# Using peakpower for max spec – 1550 Serial –

Krister Fröjdh, Peter Öhlen (Optillion)  
[krister.frojdh@optillion.com](mailto:krister.frojdh@optillion.com)

# 1550 nm TX power level: current status

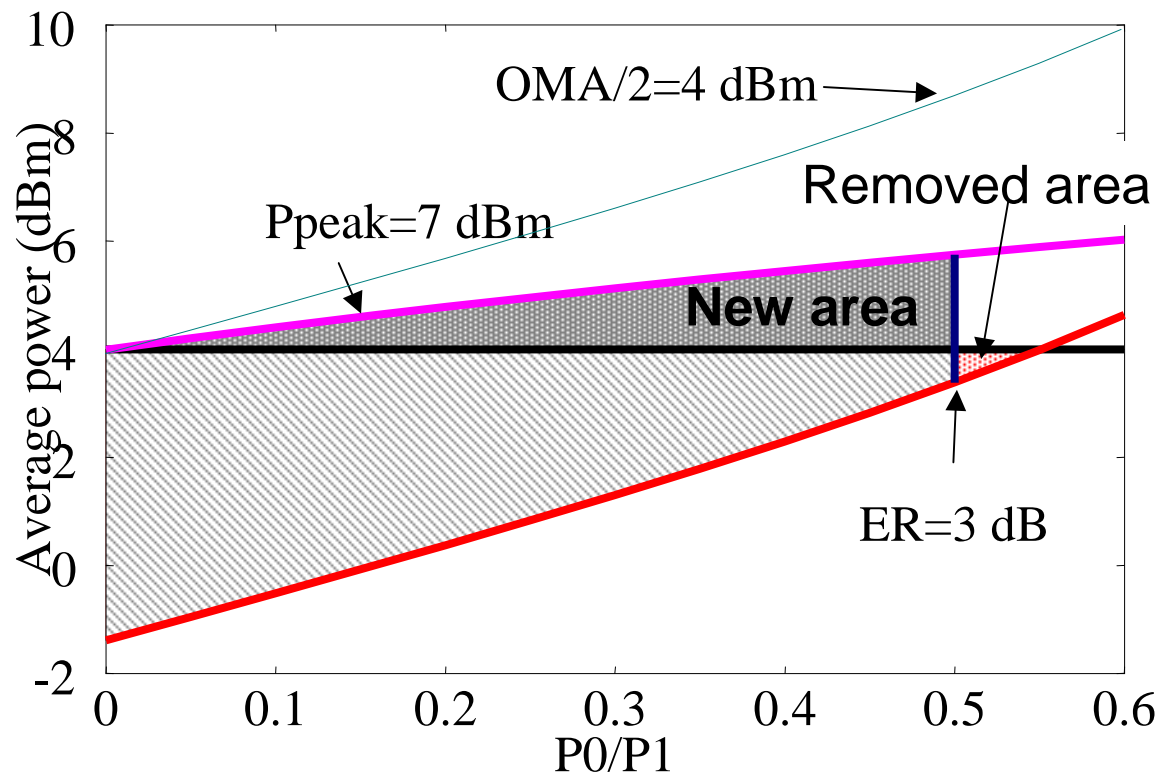
## Max power limit 1550 nm

- Eye safety is no problem (10 dBm)
- Max power is limited by receiver overload and damage level

- We checked a number of TIAs on the market:
  - Either limited by peak amplitude or OMA, not by average power
  - Good margin to the current overload level
- For PIN-detectors, peak power typically is damage and saturation parameter.

- Table 52-13-10
  - Peak power (max) 7 dBm
  - Footnote: peak power is defined as  $P_{av} + OMA/2$
  - Extinction ratio (min) 3 dB
- Table 52-14-10
  - Peak receive power 0 dBm
  - Maximum peak receive power for damage 7 dBm
